CITY OF BURLINGTON
BUILDING SERVICES
REVIEWED
FOR PERMIT ISSUANCE
DATE July 8, 2022
PERMIT NUMBER 22-005526
EXAM WH

Project Description : ROLLING MEADOWS PUBLIC SCHOOL RENOVATIONS

Drawing Description : GROUND FLOOR CEILING DEMOLITION

1 / M-4 GROUND FLOOR - NEW LAYOUT
SCALE 1:100

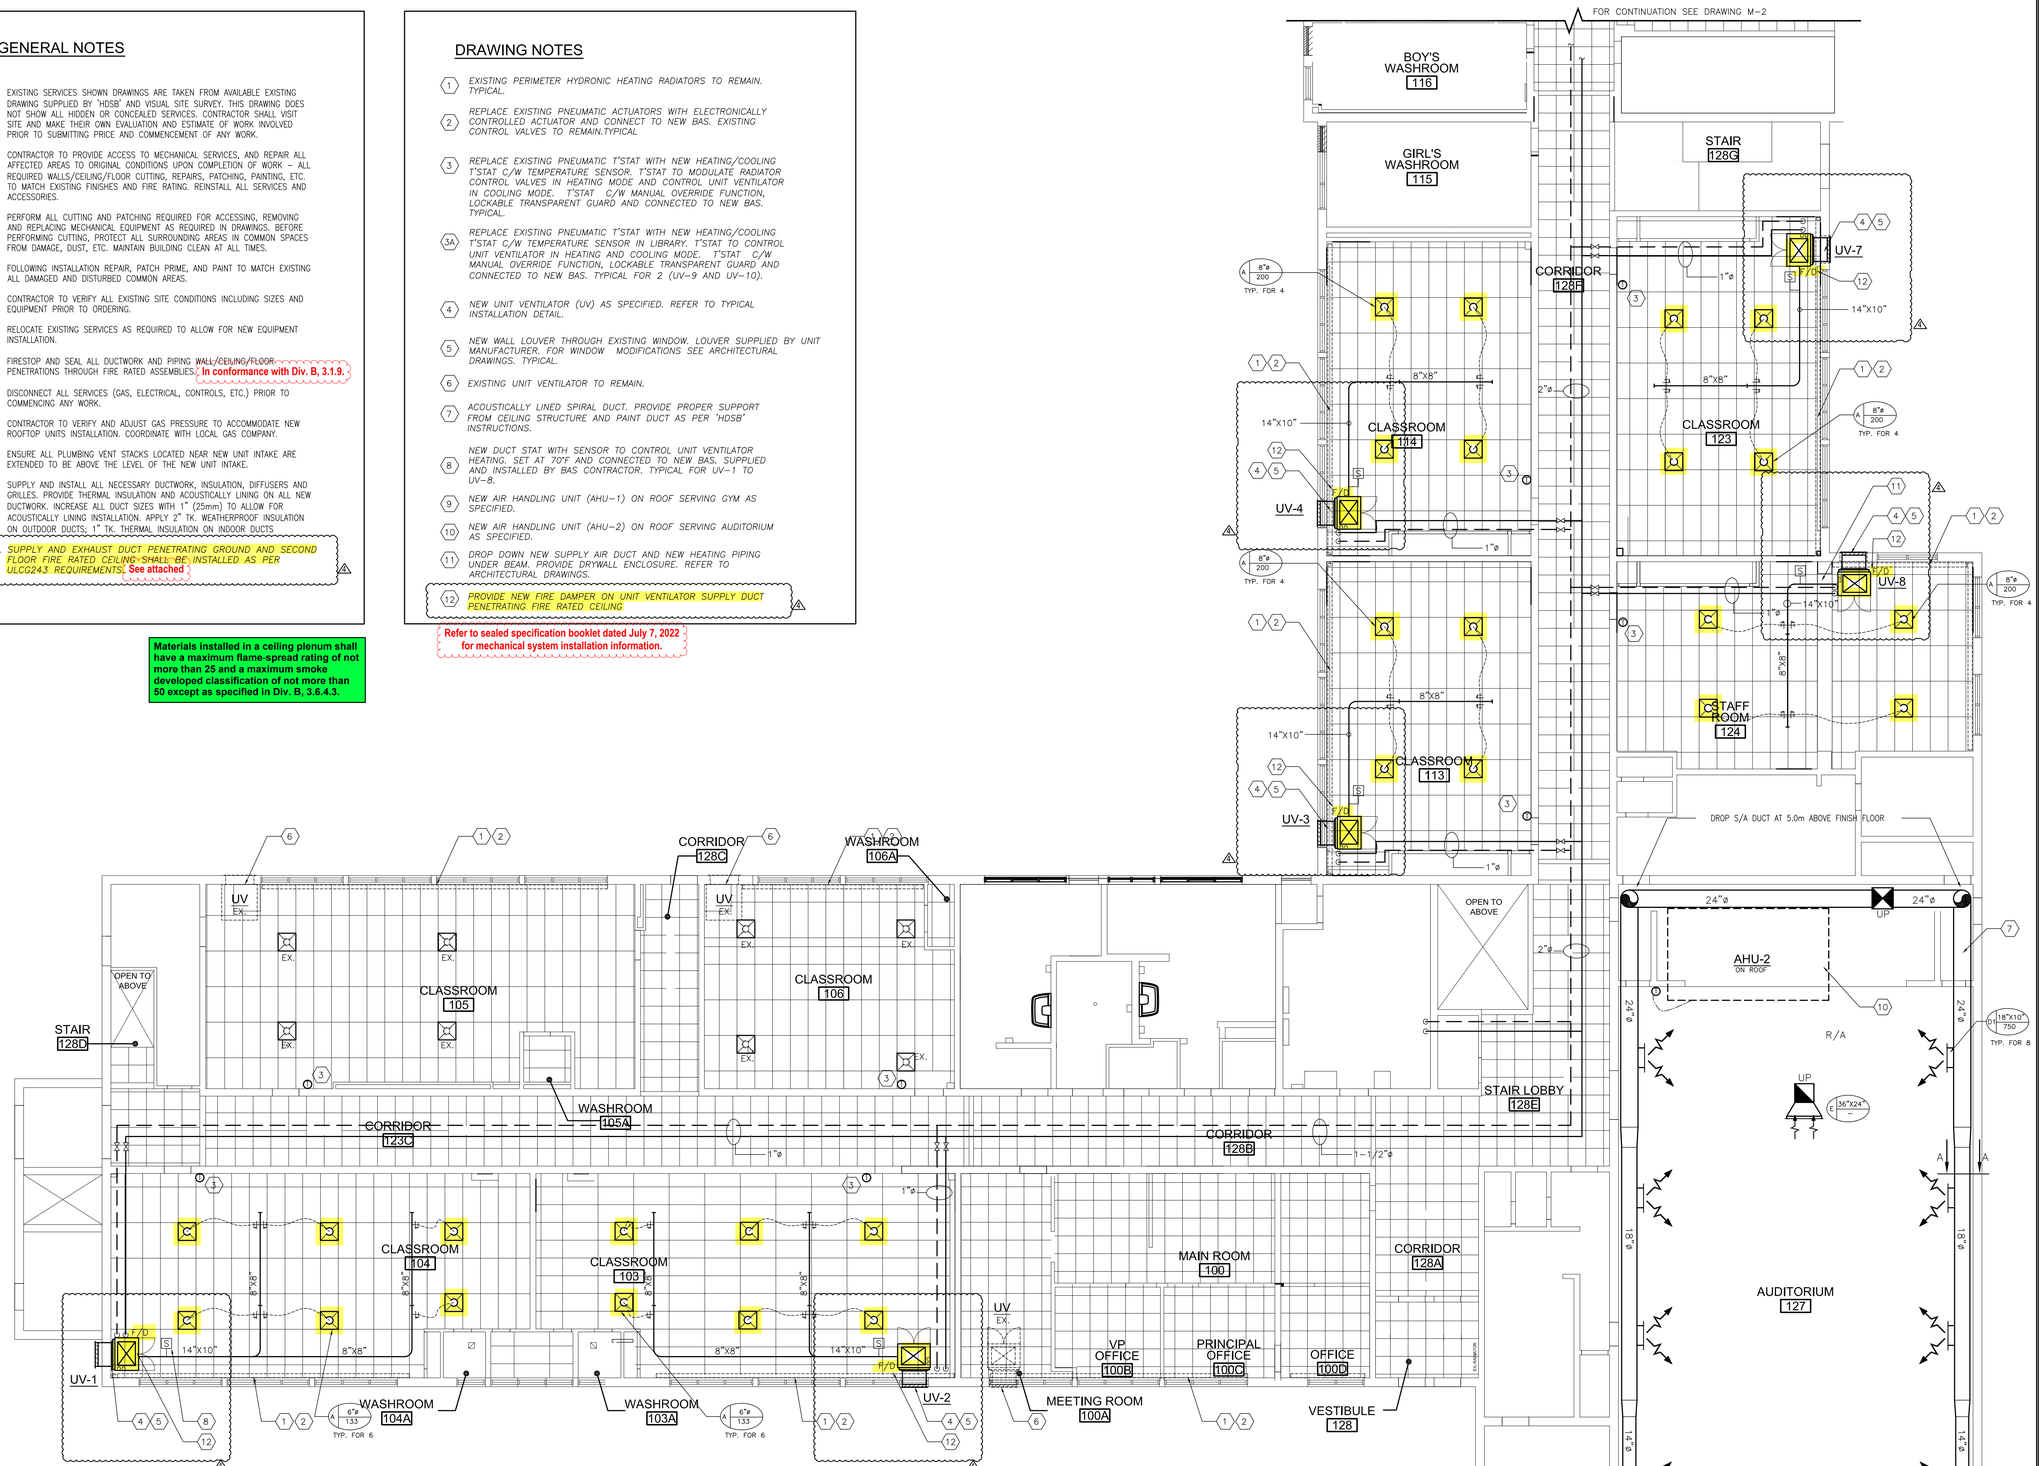
6. RELOCATE EXISTING SERVICES AS REQUIRED TO ALLOW FOR NEW EQUIPMENT INSTALLATION.
7. FIRESTOP AND SEAL ALL DUCTWORK AND PIPING WALL/CEILING/FLOOR PENETRATIONS THROUGH FIRE RATED ASSEMBLIES. **In conformance with Div. B, 3.1.9.**

12. *SUPPLY AND EXHAUST DUCT PENETRATING GROUND AND SECOND FLOOR FIRE RATED CEILING SHALL BE INSTALLED AS PER ULCG243 REQUIREMENTS.* **See attached** (A)

Materials installed in a ceiling plenum shall have a maximum flame-spread rating of not more than 25 and a maximum smoke developed classification of not more than 50 except as specified in Div. B, 3.6.4.3.

12. *PROVIDE NEW FIRE DAMPER ON UNIT VENTILATOR SUPPLY DUCT PENETRATING FIRE RATED CEILING* (A)

1 / M-5 GROUND FLOOR - NEW LAYOUT
SCALE 1:100

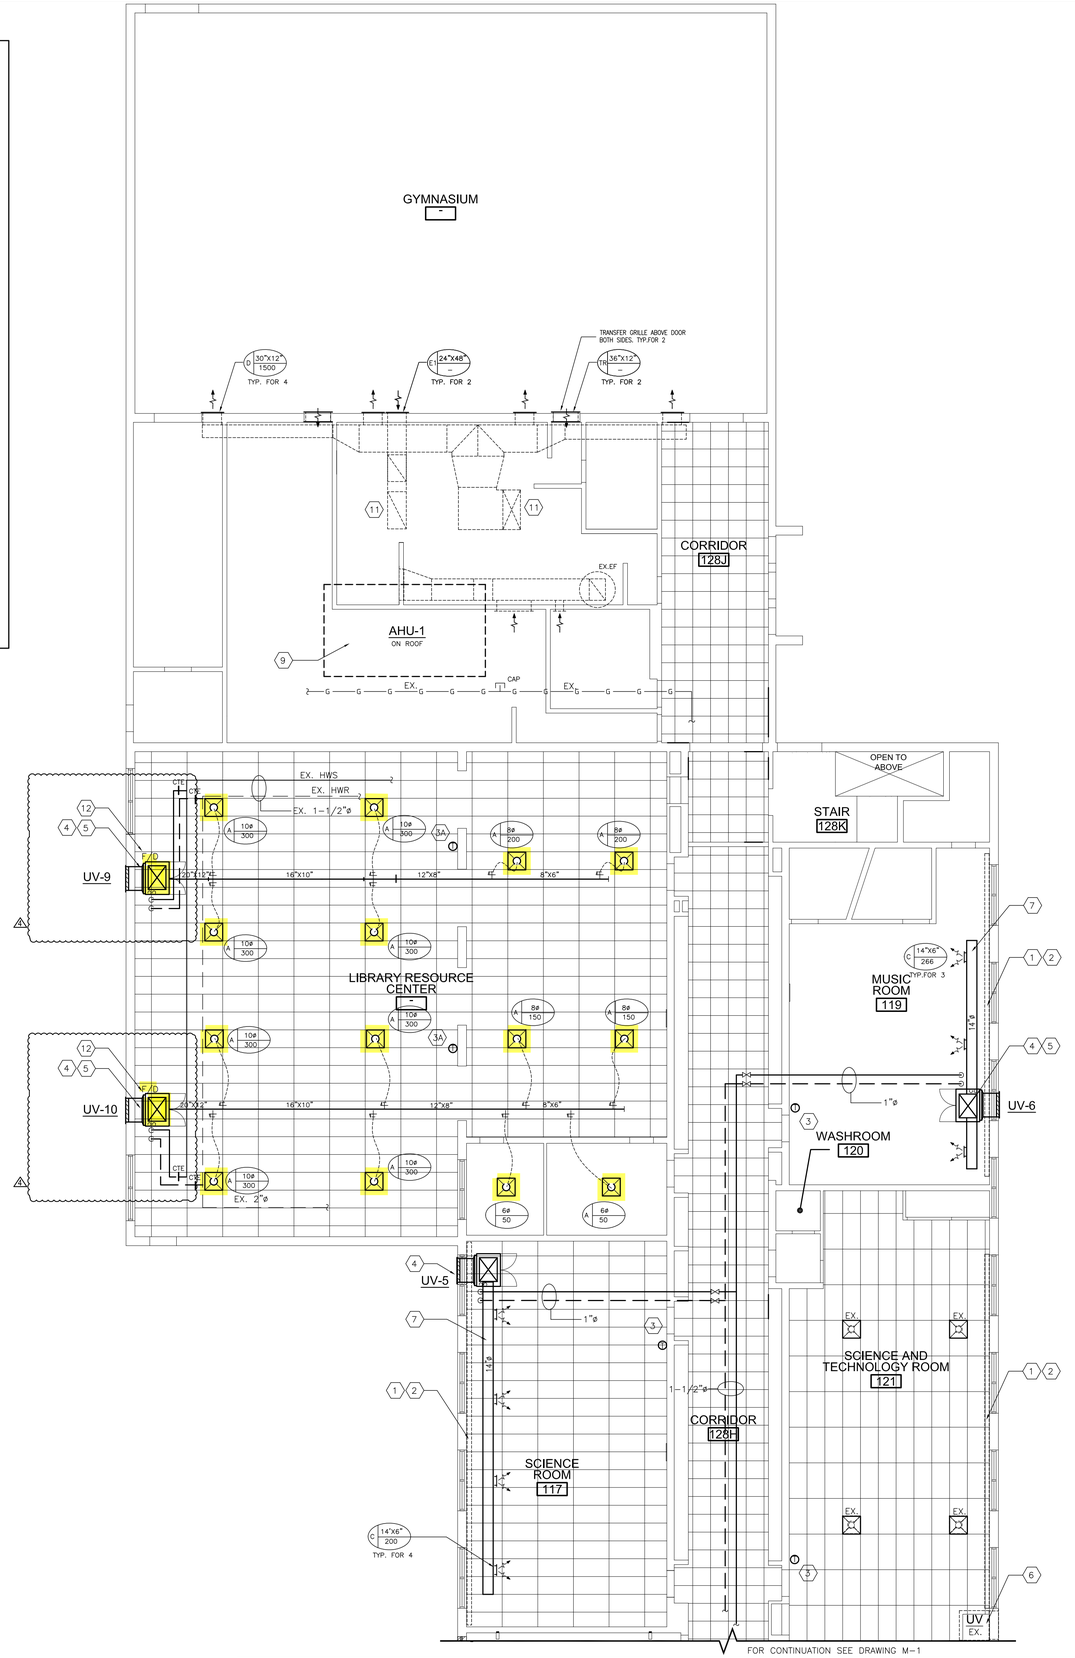
12. *SUPPLY AND EXHAUST DUCT PENETRATING GROUND AND SECOND FLOOR FIRE RATED CEILING SHALL BE INSTALLED AS PER ULCG243 REQUIREMENTS.* See attached 1 ⚠1

12. *PROVIDE NEW FIRE DAMPER ON UNIT VENTILATOR SUPPLY DUCT PENETRATING FIRE RATED CEILING.* ⚠1

1 M-6 SECOND FLOOR - NEW LAYOUT
SCALE 1:100

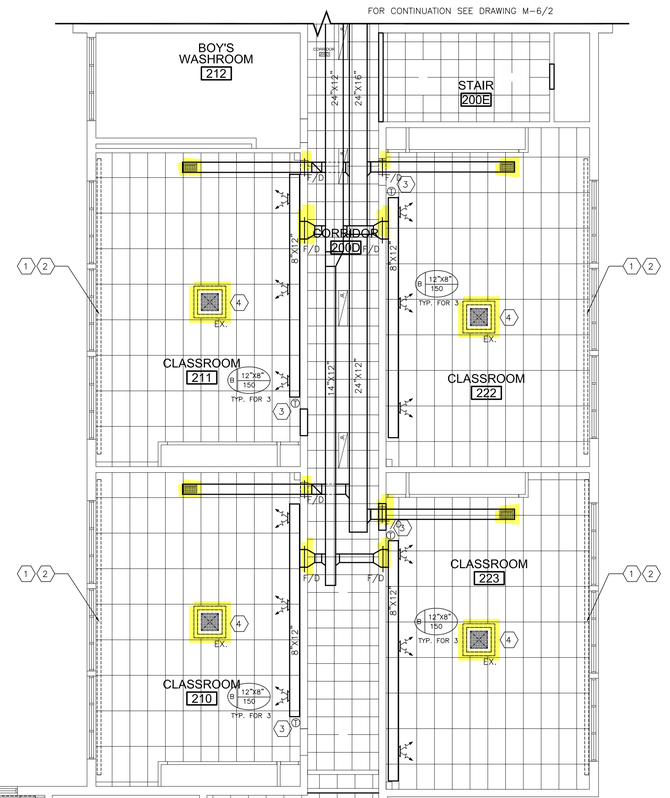
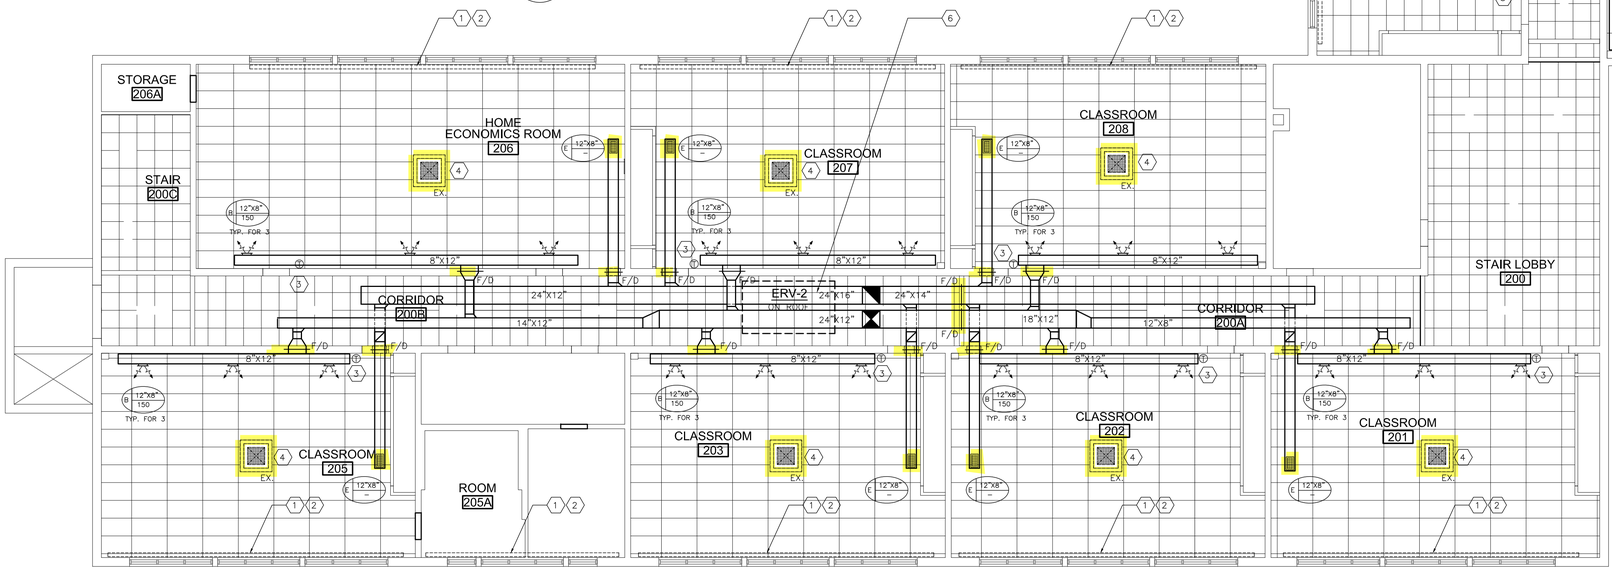
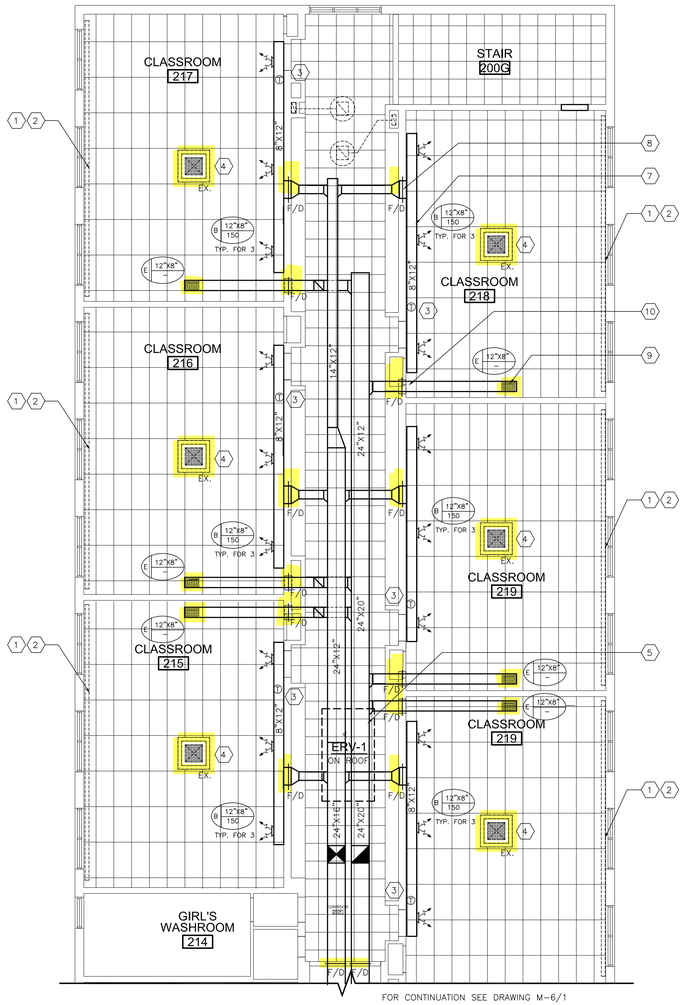
4. *EXISTING HEAT PUMP CEILING UNIT TO REMAIN.*
   Open size penetrating ceiling membrane shall be limited to 576 sq.in. with a max. dimension of 24 in. and be fitted with damper per ULC Design No. G243

8. REUSE EXISTING WALL OPENING FOR NEW SUPPLY AIR DUCT. PROVIDE FIRE DAMPER. REPAIR WALL AFTER NEW INSTALLATION. TYPICAL
9. *NEW EXHAUST AIR GRILLE AND DUCT ABOVE SUSPENDED CEILING. TYPICAL FOR CLASSROOMS.* **With damper per ULC Design No. G243**

10. PROVIDE NEW 16"X8" WALL OPENING FOR NEW EXHAUST AIR DUCT. PROVIDE FIRE DAMPER. REPAIR WALL AFTER NEW INSTALLATION. *TYPICAL* **And Smoke damper.**

Combination fire and smoke dampers shall be installed in conformance with Div. B, 3.1.8.9A. and NFPA 80-2013, 19.2.

1 M-11 BOILER ROOM - DEMOLITION
SCALE 1:50

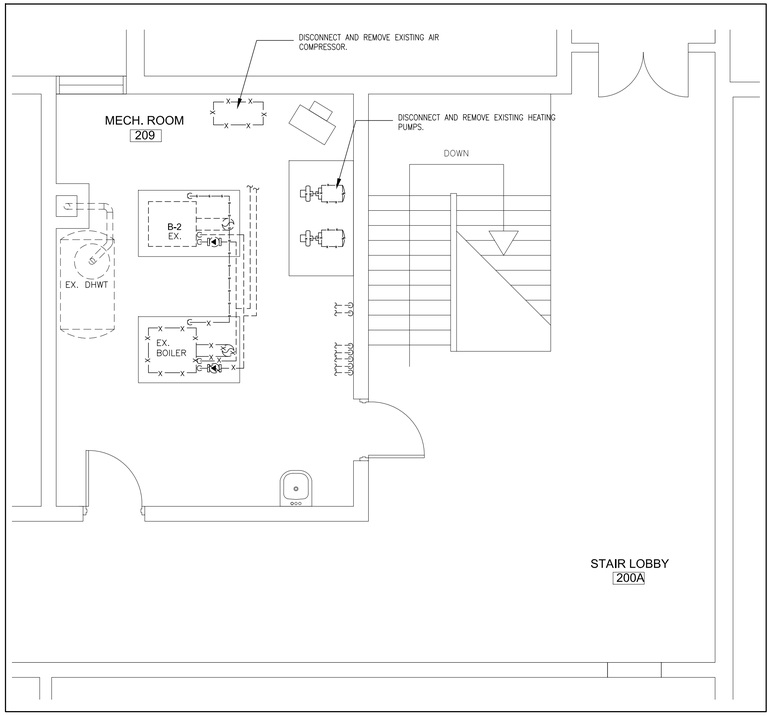
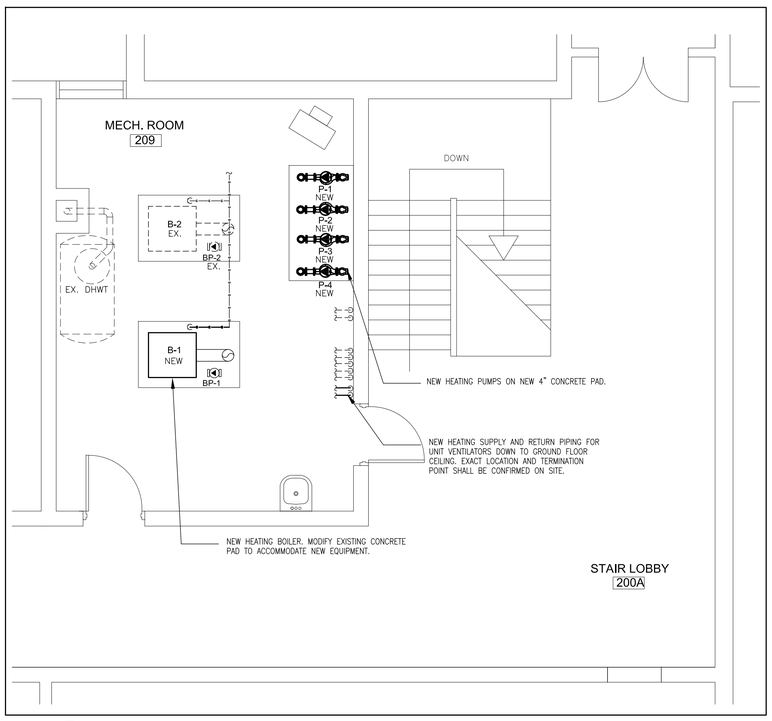
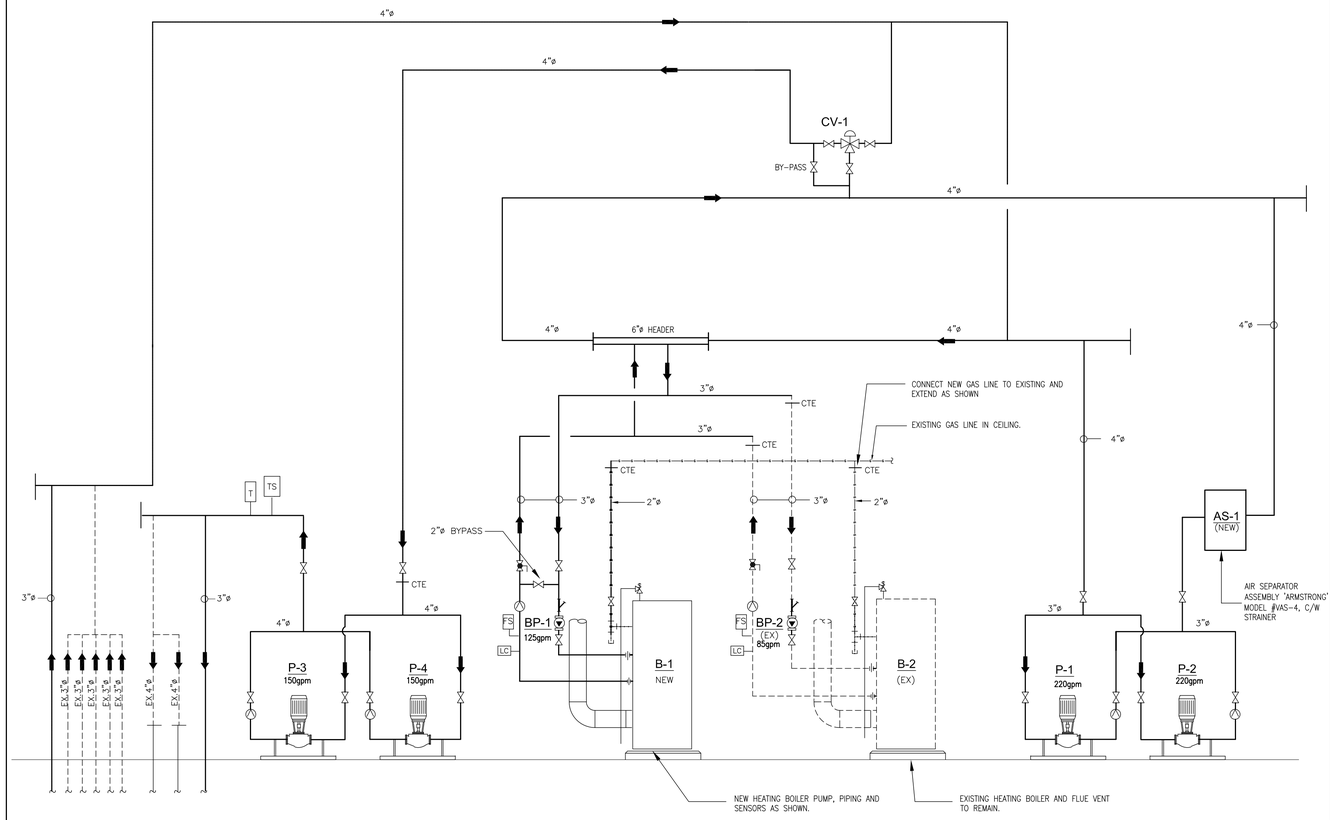
Backflow Prevention Devices shall be selected, installed and tested in conformance with CAN/CSA-B64.10-2017, "Manual for the Selection and Installation of Backflow Prevention Devices".

Pipe Materials and Pipe Fittings shall conform to Div. B, 7.2. of the OBC.

Combustible piping, tubing and associated adhesives shall have a maximum flame-spread rating of not more than 25 except when concealed in a wall or concrete floor slab as per Div. B, 3.1.5.16.(1).
